Re Rasp, silver lead and zinc mine – Modification No 4

This letter addresses each comment within the EPA submission (EPA reference DOC17/236124-21 dated 17 May 2017) sequentially below.

1 Response to EPA Submissions

Figure 1-1: Box and whisker plots of 24-hour average PM₁₀ measurements by calendar year at TEOM1

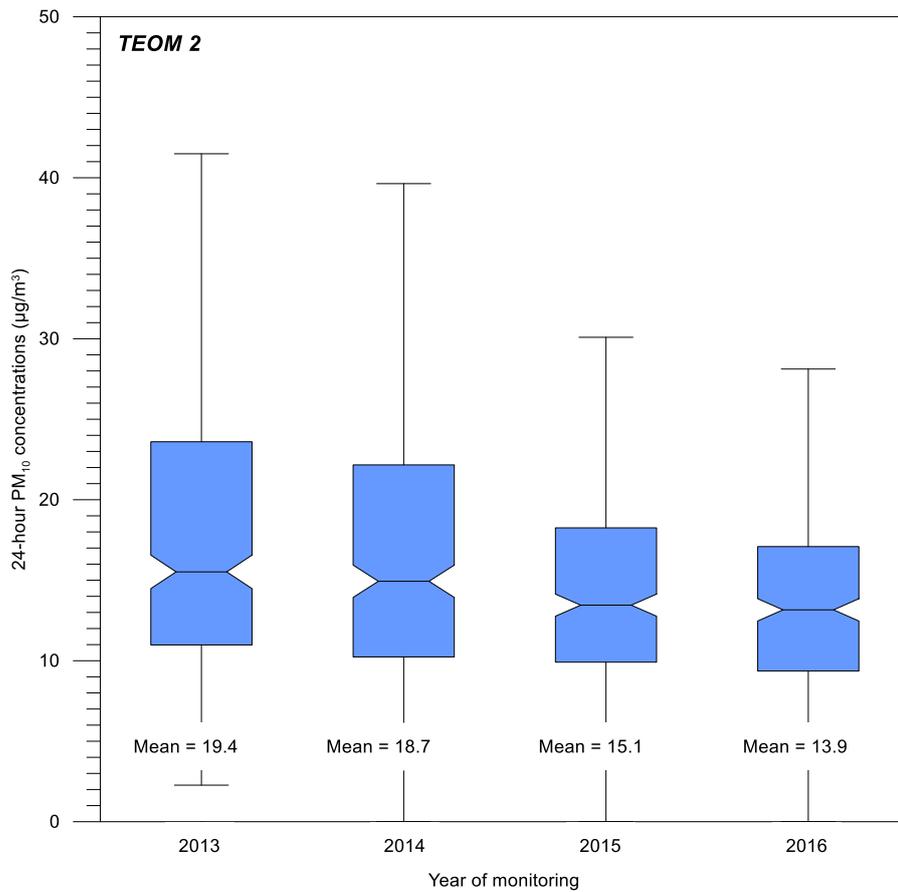
adopted annual PM_{10} values are trending towards minimum reported values, when analysed by box and whisker plots (assessment figures E-10 and E-11). Adopted annual $PM_{2.5}$ values show far greater inter monitor variation than PM_{10} , indicating either a data error or an unidentified dominant $PM_{2.5}$ emission source(s) influencing TEOM2 values.

- b. Two Tapered Element Oscillating Microbalances (TEOMs) measuring PM_{10} at two locations on site.
2. The adopted annual mean concentrations presented in the AQ Assessment (Figures E-10 and E11) have been reviewed and were found to be in error, with the box plots showing the incorrect median and quartile data. The adopted annual was correct. Note that the error in the box and whisker plot had no influence on the results. The box and whisker plots of the 24-hour average PM_{10} concentrations measurements for TEOM1 and TEOM2 have been regenerated with a finer resolution and show an annual year (rather than financial year) results and are shown in Figure 1-1 and Figure 1-2, respectively. The original figures can be seen in Figure E-10 and E11 of Appendix E in the AQ Assessment. The adopted annual mean values in the AQ Assessment align with the updated plots presented in this letter.

It is noted that BHOP incorrectly issued the same results for Both TEOM1 and TEOM 2 for the month of November and December. The updated monitoring results have now been provided by BHOP for November 2016 and December 2016. The reported annual mean PM_{10} values reflect the updated data sets (see Figure 1-1 and Figure 1-2). The updated annual average background concentrations are now $13.0\mu\text{g}/\text{m}^3$ (no change) for receptors using the TEOM1 dataset and $13.9\mu\text{g}/\text{m}^3$ (previously $13.1\mu\text{g}/\text{m}^3$) for receptors where the TEOM2 dataset was adopted.

Figure 1-6: Location of the on-site TEOM and proposed additional monitors

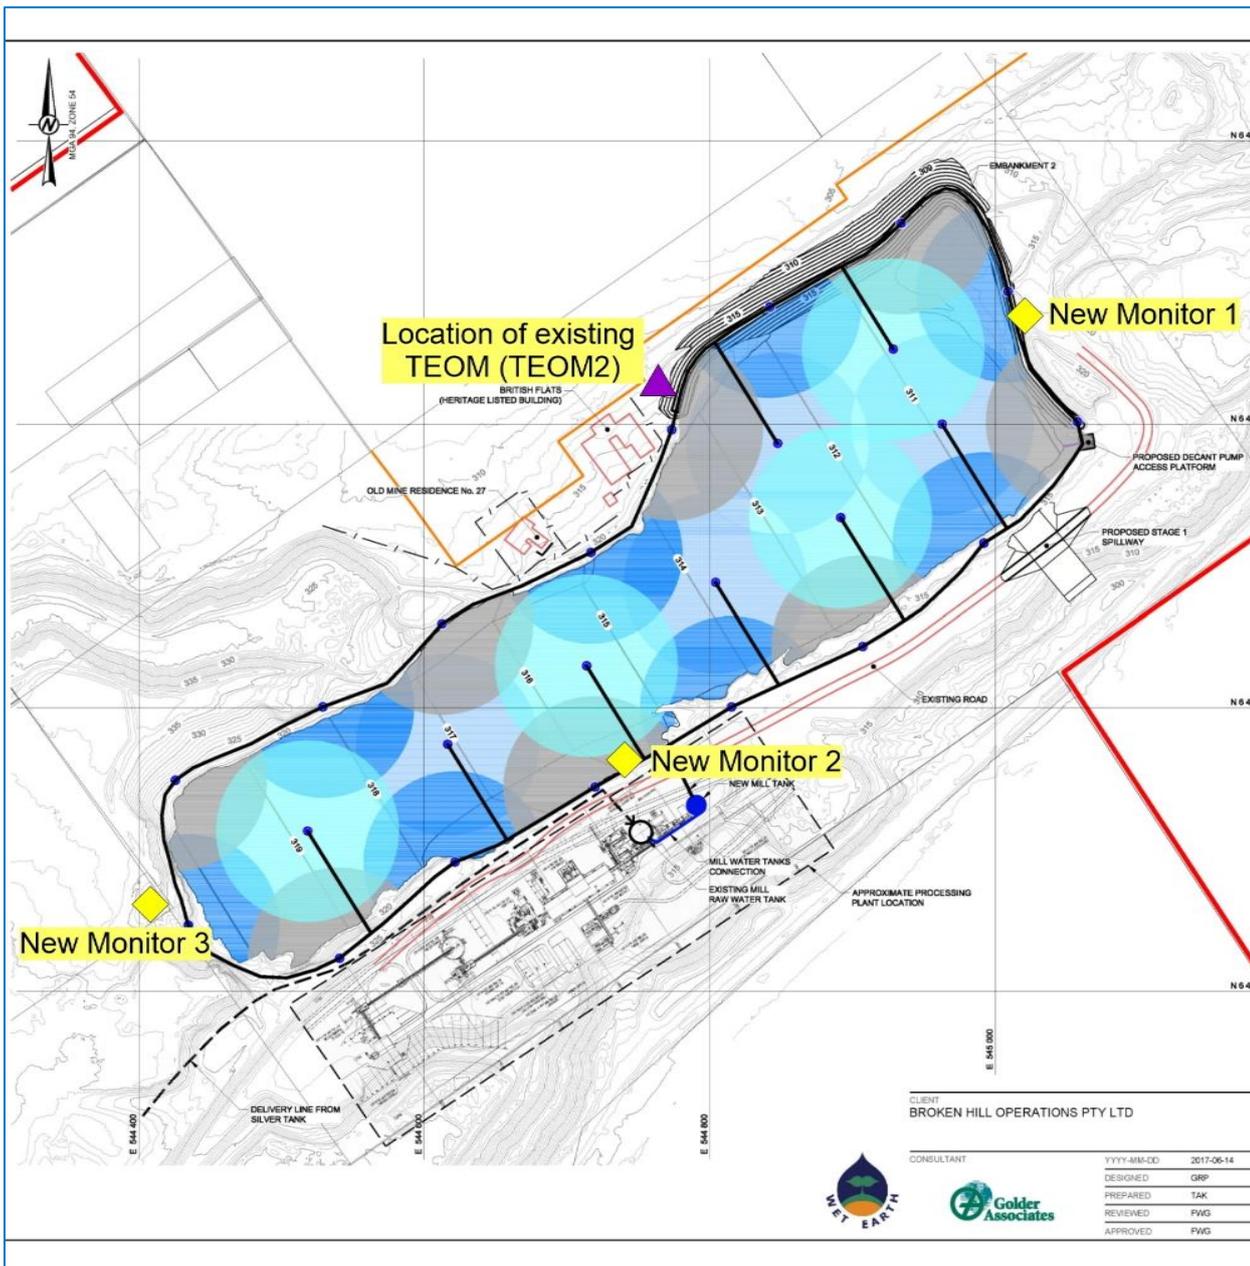
Further detail on a proposed management monitoring regime, including as a minimum, real time particle monitoring at representative locations on all sides of TSF2; telemetry notifications; response mechanisms; responsibilities; and quality assurance.

BHOP currently monitors PM₁₀ concentrations and wind speed/direction continuously at two locations (north and south of current mining operations). Only the TEOM located to the north is located on site and relevant to potential TSF emissions.

Monitoring will continue at these locations, and will be supplemented with additional monitoring locations representative of conditions at the TSF. The location of the on-site TEOM and proposed additional monitors is shown in Figure 1-6.
